Technical Service Bulletin

94 Heavy condensation in headlights

94 13 29 2035920/1 December 5, 2013.

Model(s)	Year	VIN Range	Vehicle-Specific Equipment
TT	2007 - 2013	All	Not Applicable

Figure 1. Heavy condensation.

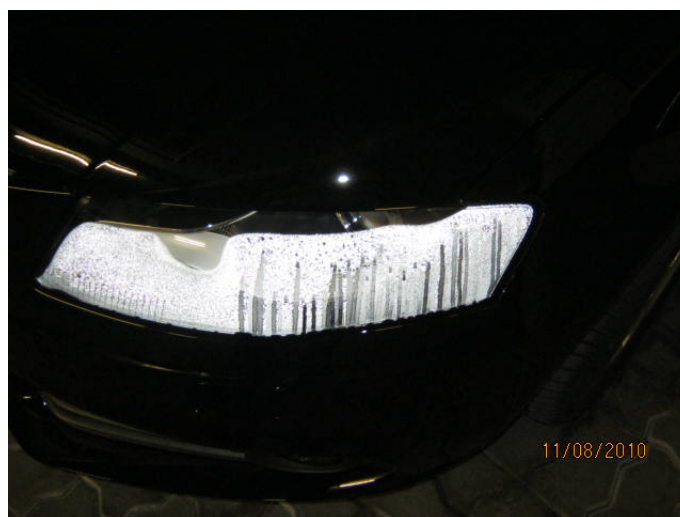
- Heavy condensation has built up in the headlight (Figure 1).
- Condensation only dissipates after the car is driven with the headlights on for at least ten minutes.

- There is no visible external damage to the headlight lens or housing.

Humid outside air (such as during rain) can enter into the headlights through the ventilation hose.

1. Use compressed air (less than 30 PSI) to clear the headlight lens.
2. Replace the ventilation hose (Figure 2) of the affected headlight with part number **8J0941717B** (left) and/or **8J0941718** (right) to reduce the humidity ingress. Hose should be fitted so that the filter element hangs freely behind the cross-member (Figure 3).
